**OP 2023_5560 – 368-380 PORT DOUGLAS ROAD, PORT DOUGLAS – BULK EARTHWORKS
RESPONSE TO REQUEST FOR INFORMATION**

This letter aims to respond to the Request for Information from Douglas Shire Council [Council Ref: OP 2023_5560/1 (1204830) in relation to the proposed development at 368-380 Port Douglas Road, Port Douglas. For clarity, the requests have been reproduced below with the response following in *blue italicised text*.

Image 1 - stripped topsoil with stockpile in the North-western corner

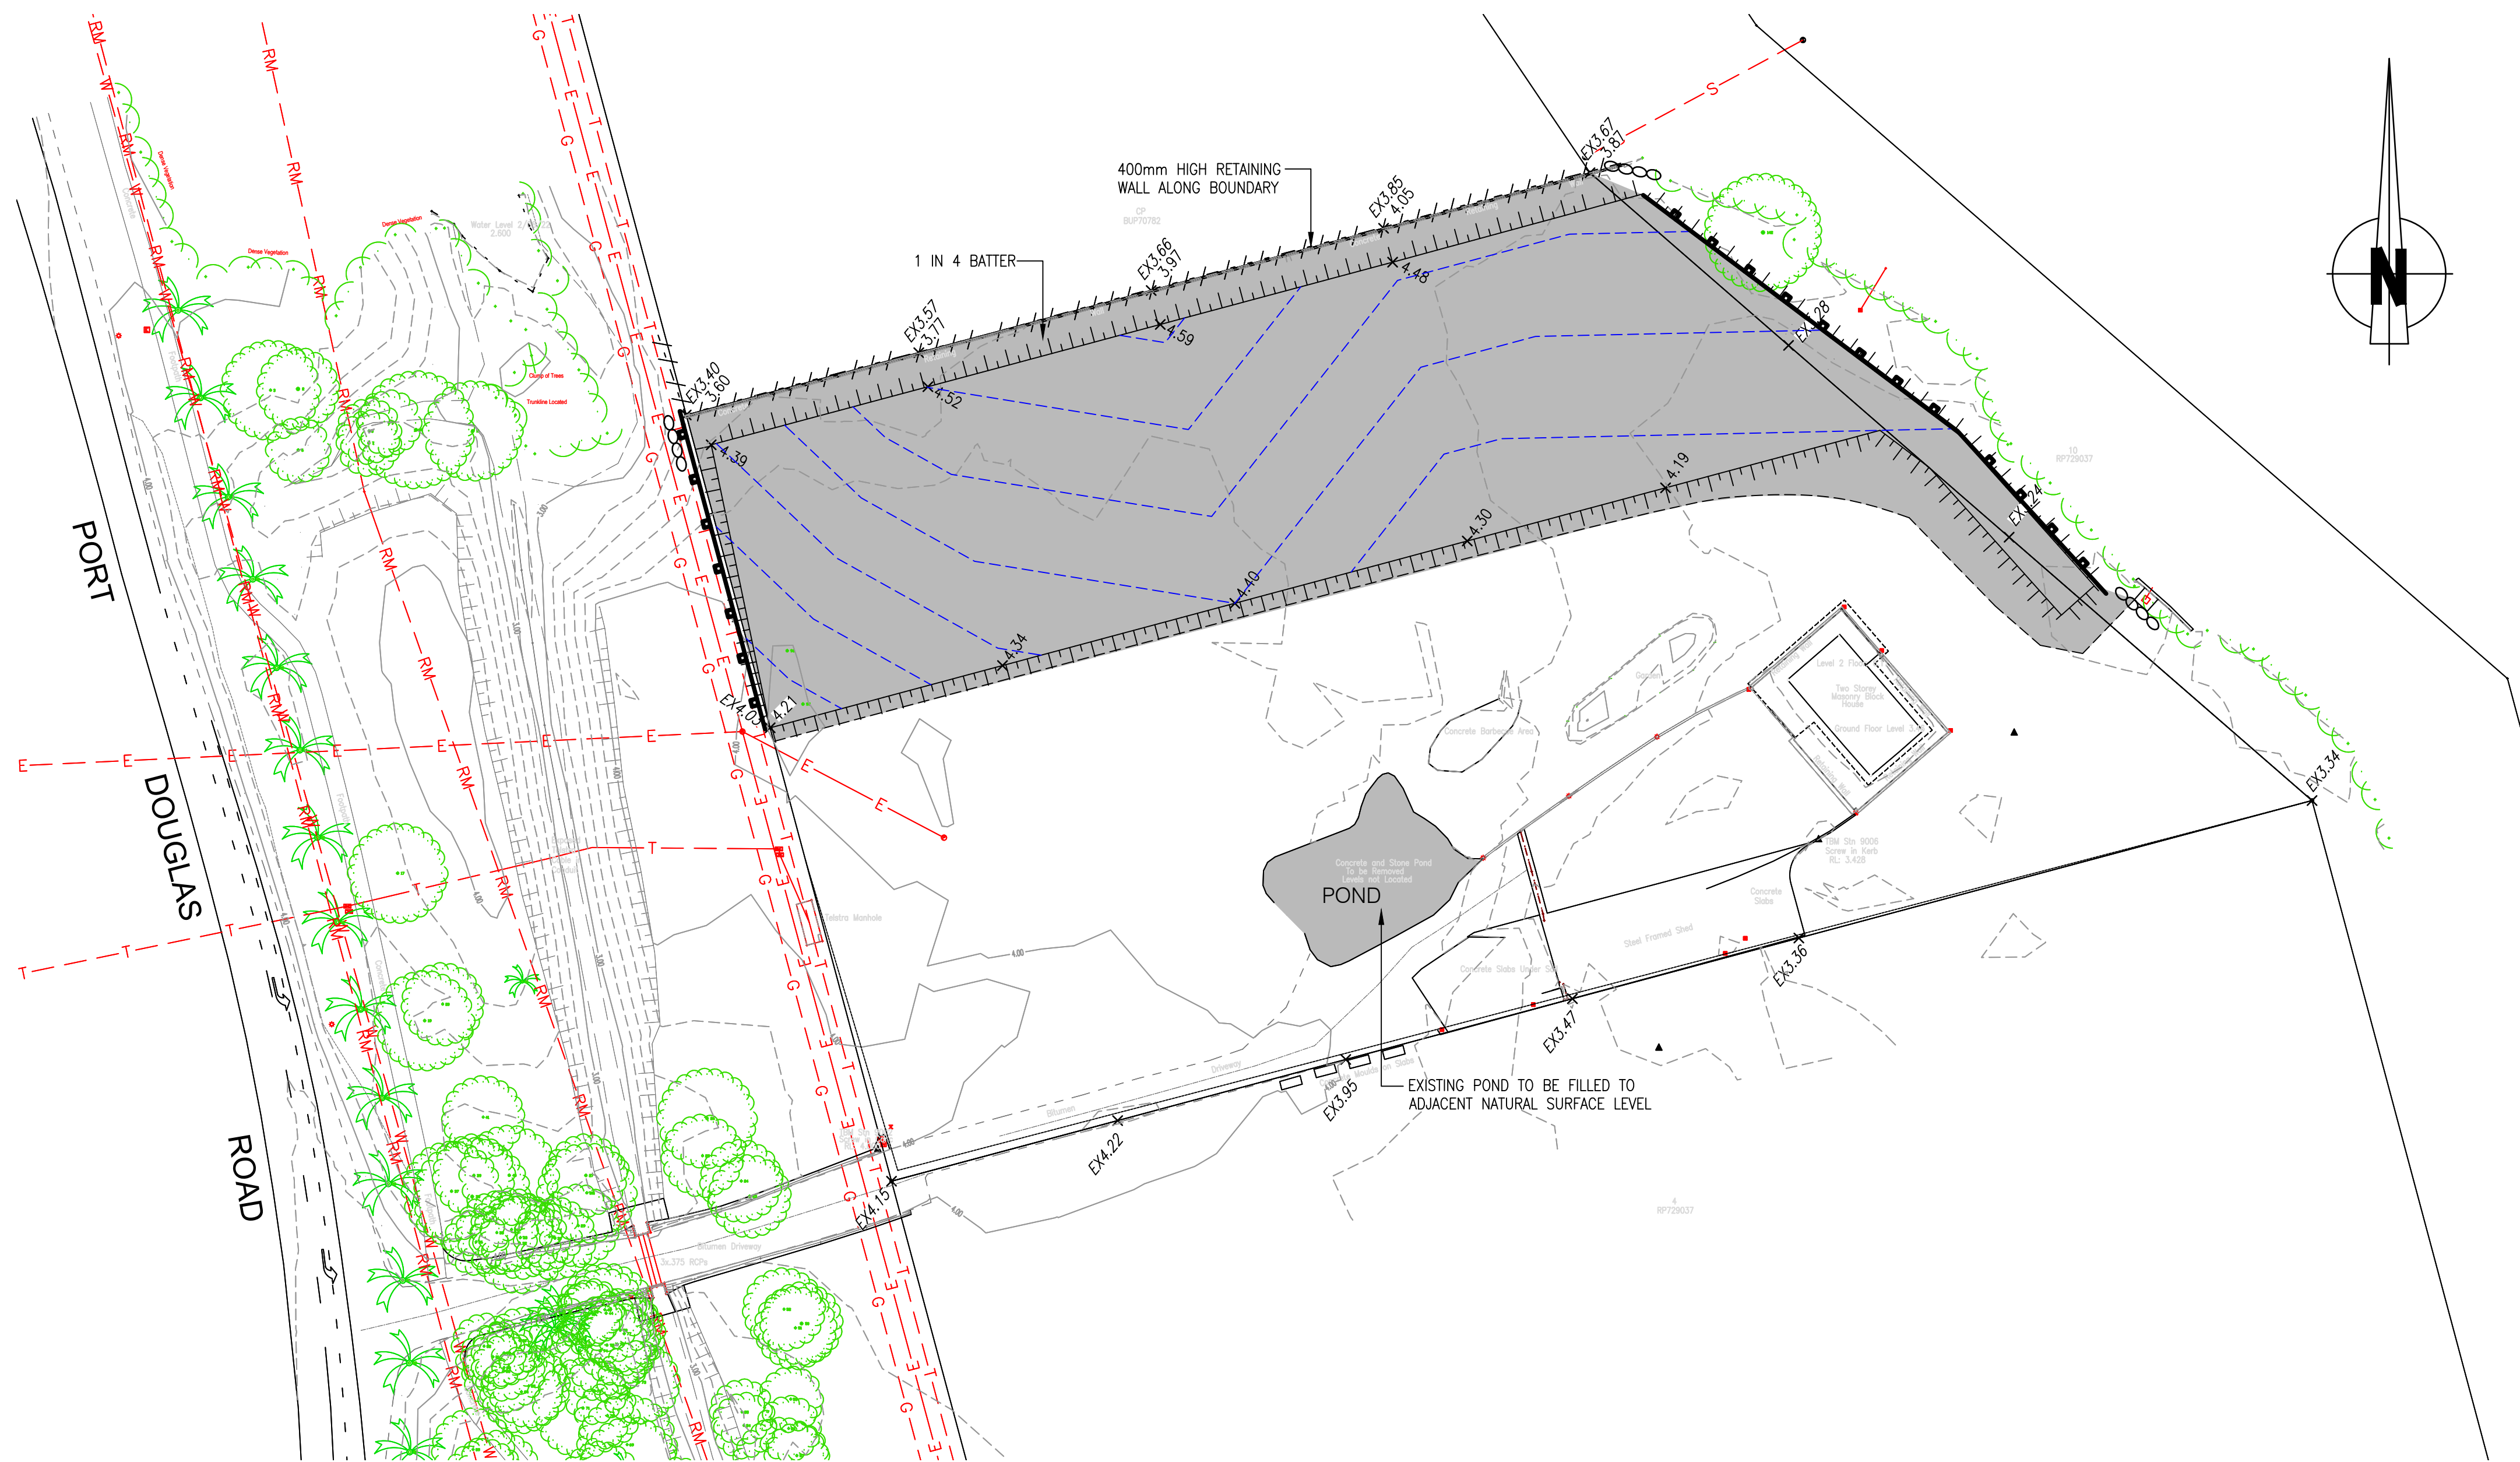
- What testing is required to verify the quality of the material currently on the site and proposed to be imported to site;
 - It is not clear if stripping of the grass and topsoil and preparation of the subgrade prior to importing the earthworks was undertaken, how will this be addressed in the proposed bulk earthworks processes currently being undertaken on site;

It is acknowledged that the topsoil has been stripped and stockpiled already (refer below image). The contractor/applicant will ensure that the stripping of topsoil has been carried out in accordance with AS3798 Section 6.1.5.

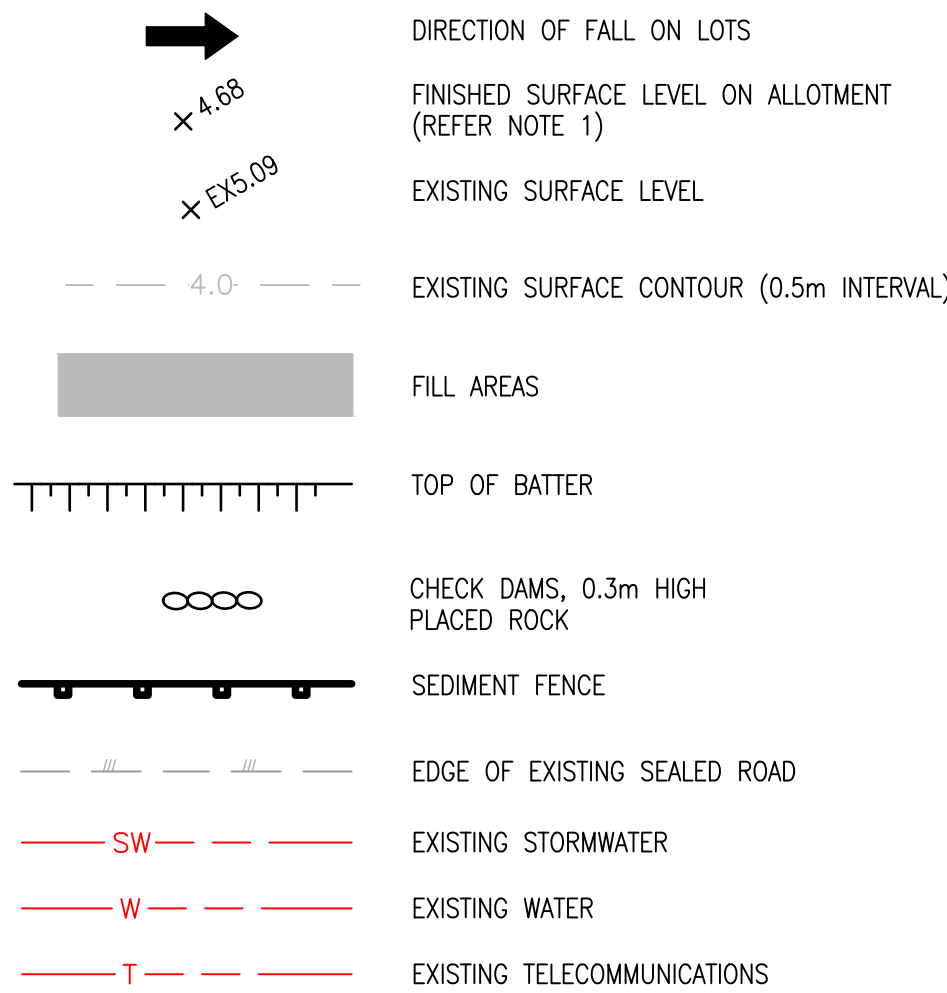
4. The applicant is to confirm that the material currently placed along the eastern extent of the site is not within the drainage path or impacting the normal flow of rainfall runoff in the local area.

The fill material placed along the Eastern boundary is located above the high bank of the drainage path and does not impact the capacity of the channel or normal flow of the drainage channel. Refer to images below.
